STAFF COMMENTS FOR PLANNING COMMISSION

SUBJECT: **CSP-07-005**

TITLE: **Archstone at Olde Towne**

REQUEST: **CONCEPT SITE PLAN APPROVAL**
For 18,350 square feet of retail;
389 apartment units

CONCEPTUAL SITE PLAN
ARCHSTONE · OLDE TOWNE GAITHERSBURG
P. 991, P. 953, P. 948, P. 951, P. 950, P. 948 & P. 990
CITY OF GAITHERSBURG ELECTION DISTRICT No. 9
MONTGOMERY COUNTY, MARYLAND

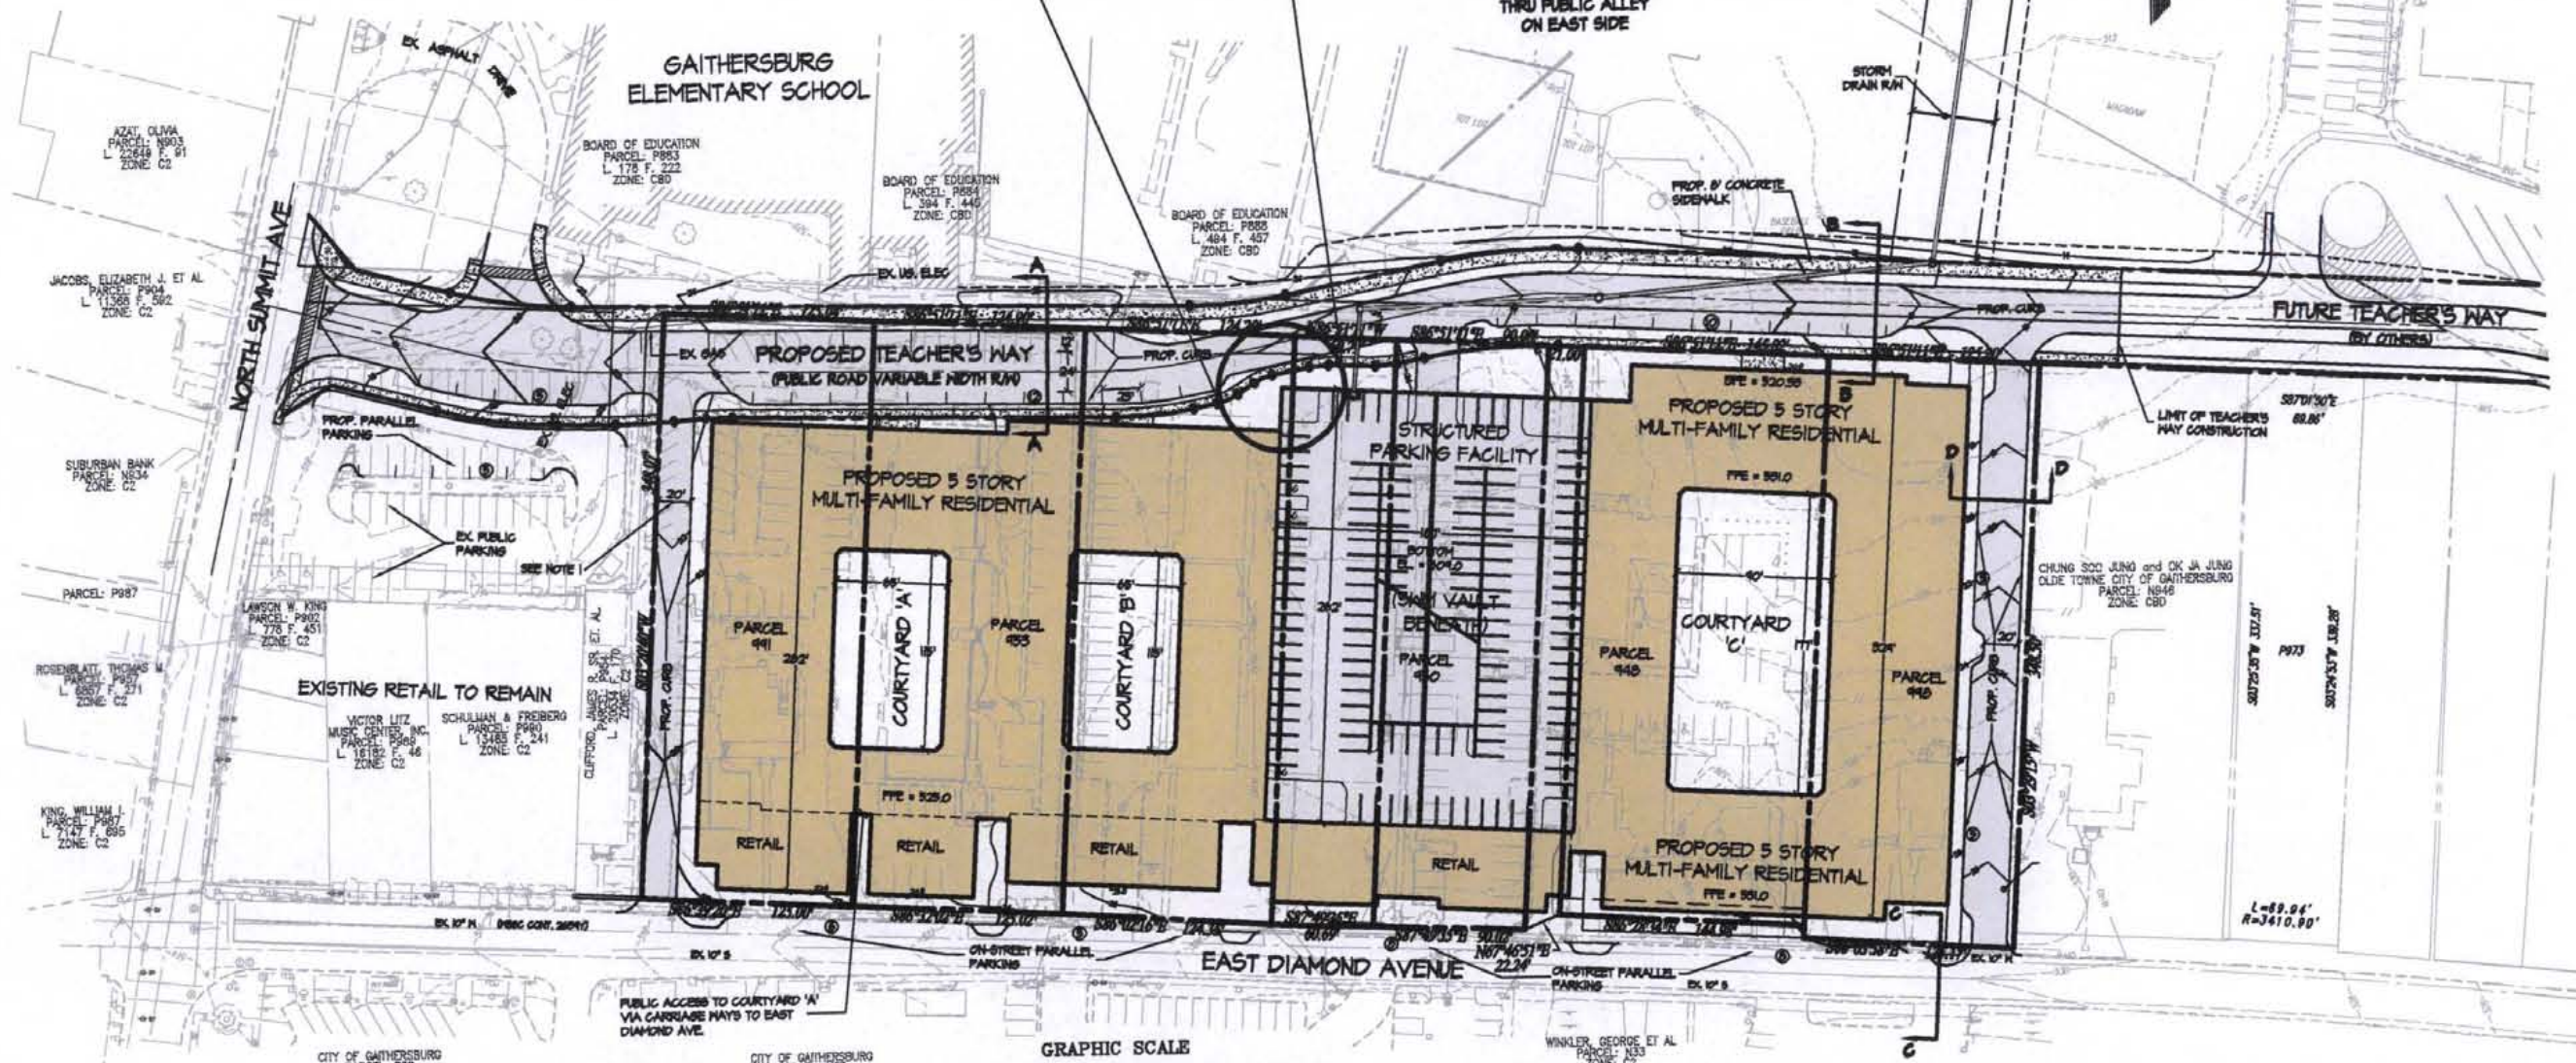
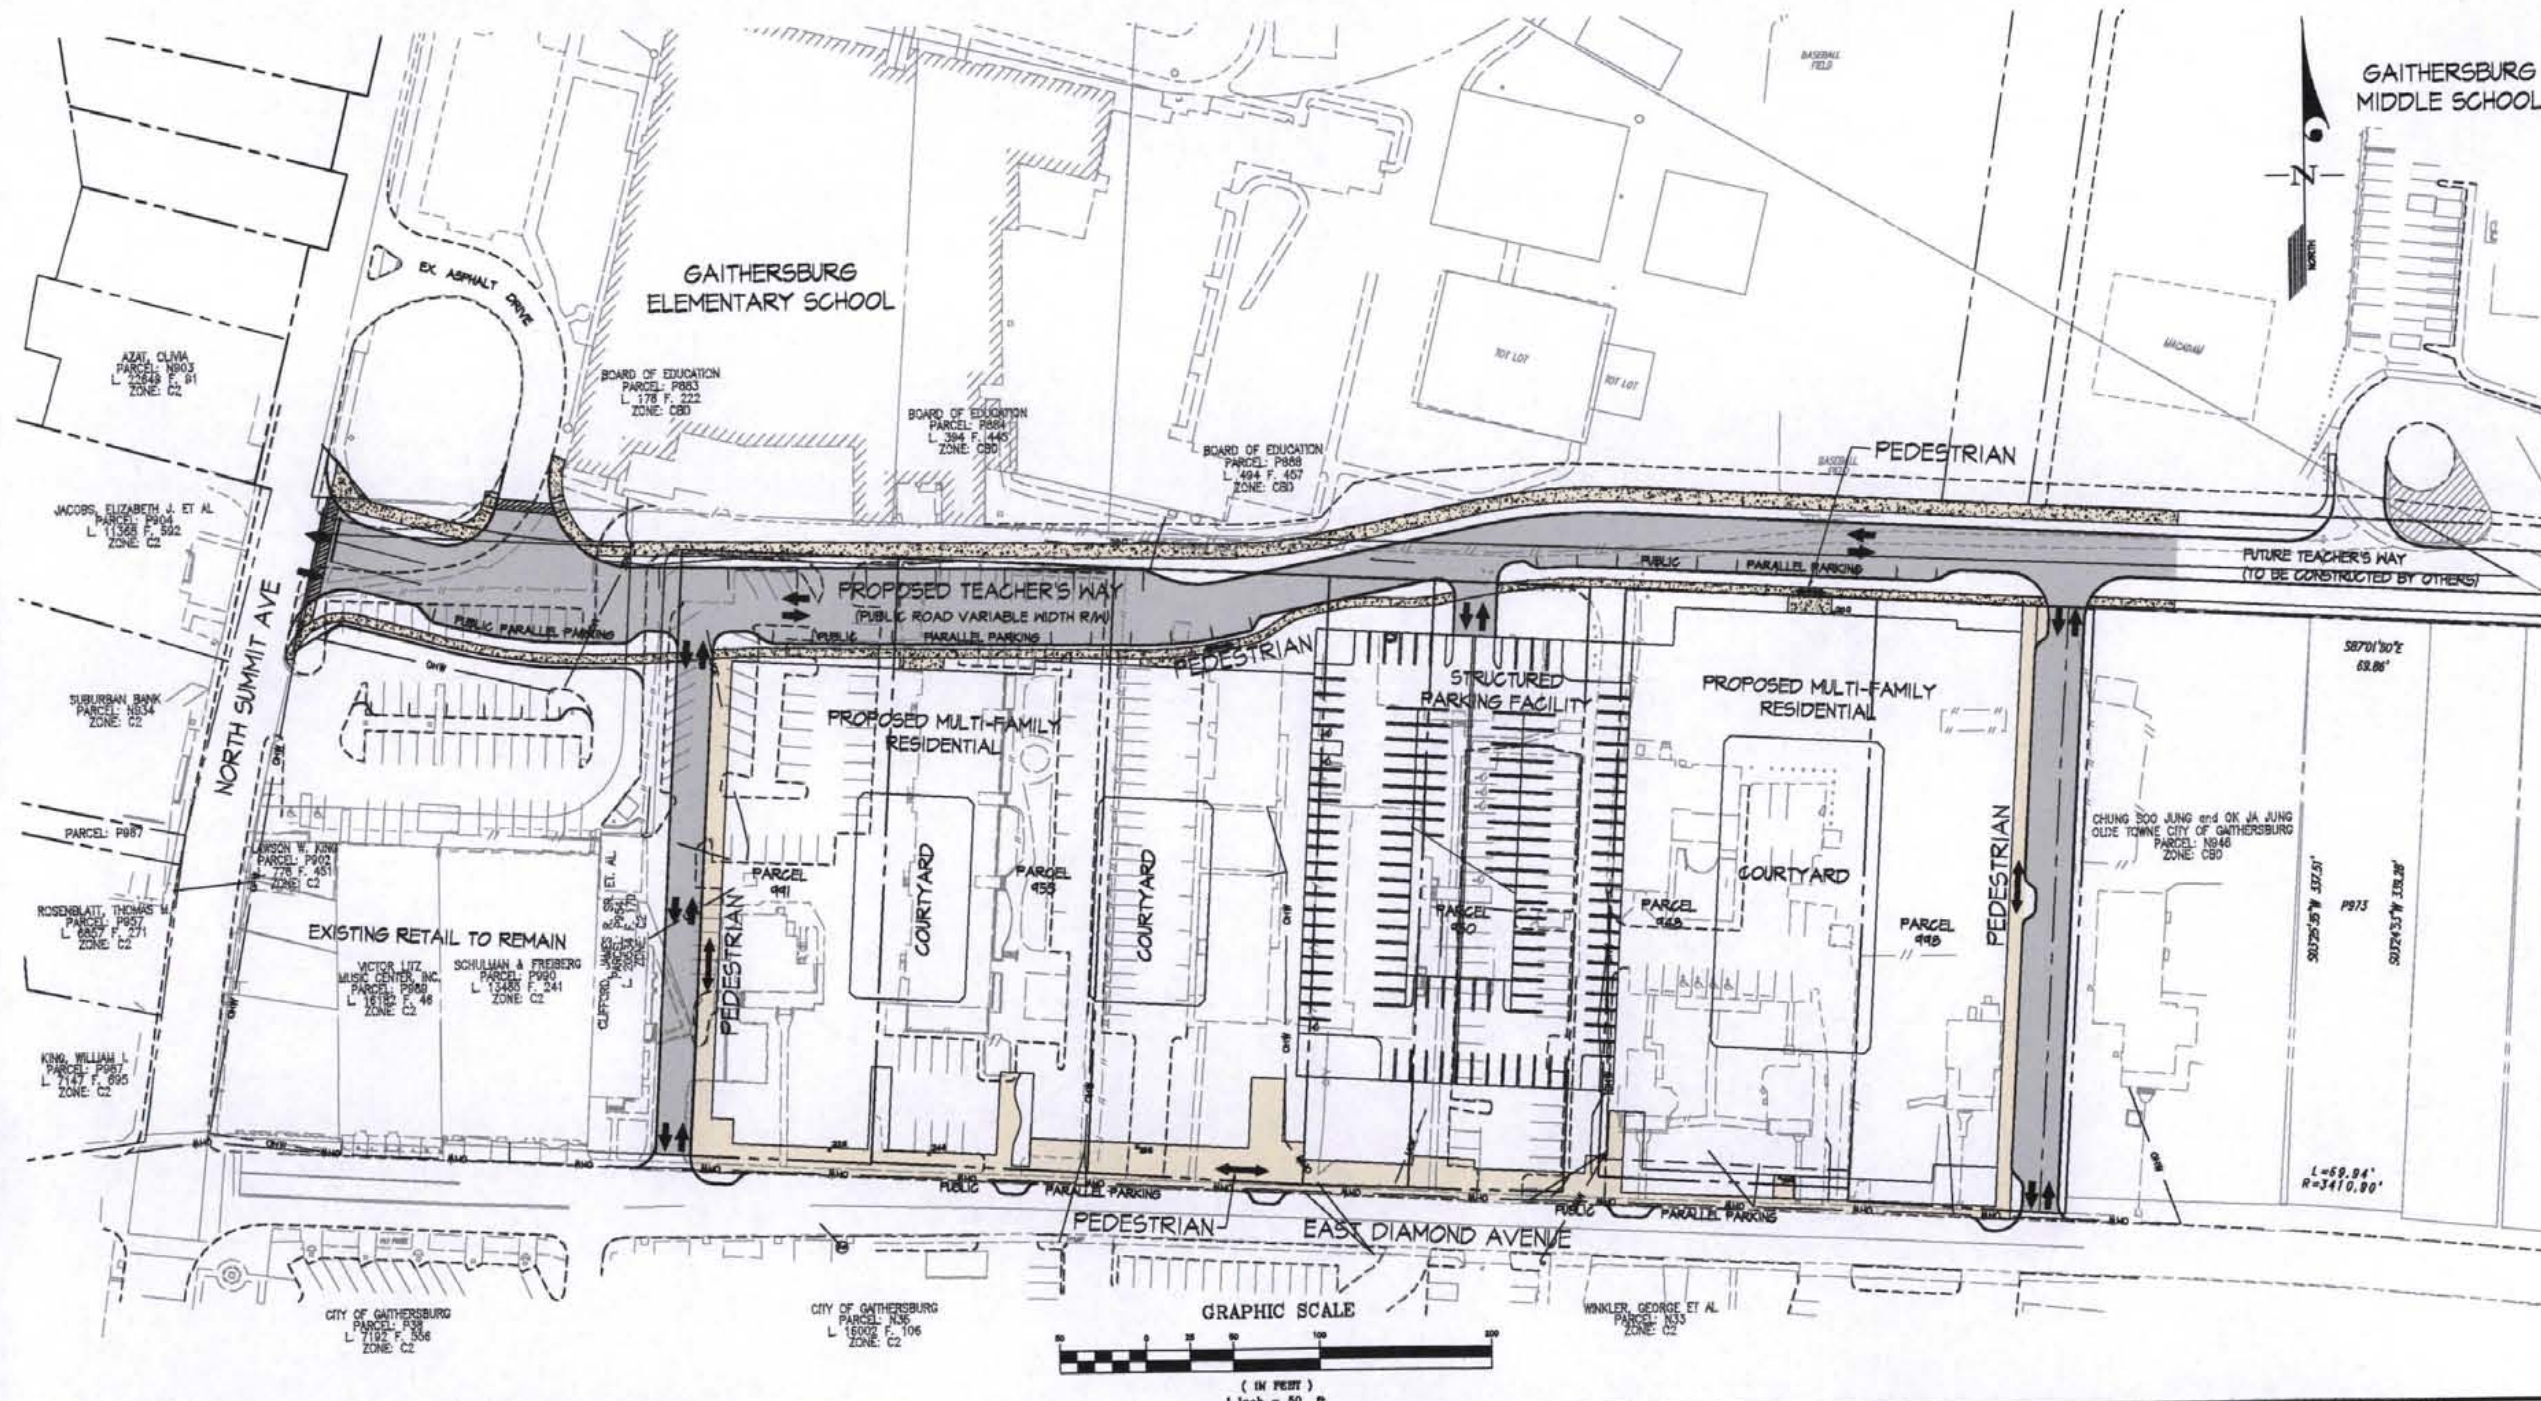
The alley to the east of the project is proposed to be private with an ingress/egress easement that will be provided for the use and benefit of the adjacent property, Parcel P954, 316 East Diamond Avenue. Staff and the applicant will continue to work on the final design of the private alley adjacent to parcel P954.

DPWPM&E has requested the applicant provide a concept utility plan prior to the submission of a preliminary/final site plan. City staff would also like for the applicant to have received conceptual approvals from the utility companies for the utility locations and easements prior to the submission of a preliminary/final site plan.

- 1. THE APPLICANT SHALL SUBMIT A CONCEPTUAL UTILITY PLAN AND RECEIVE CONCEPTUAL APPROVALS FROM THE UTILITY COMPANIES FOR UTILITY LOCATIONS AND EASEMENTS AT THE SUBMISSION OF THE PRELIMINARY/FINAL SITE PLAN;**
- 2. THE APPLICANT SHALL SUBMIT, AND RECEIVE APPROVAL FOR, A FINAL TRAFFIC IMPACT STUDY PRIOR THE SUBMISISON OF THE PRELIMINARY/FINAL SITE PLAN;**
- 3. THE APPLICANT SHALL SUBMIT A REVISED PARKING WAIVER REQUEST AT PRELIMINARY/FINAL SITE PLAN APPROVAL; AND**
- 4. THE APPLICANT SHALL WORK WITH STAFF ON THE FINAL DESIGN OF THE PRIVATE ALLEY ADJACENT TO PARCEL P954.**
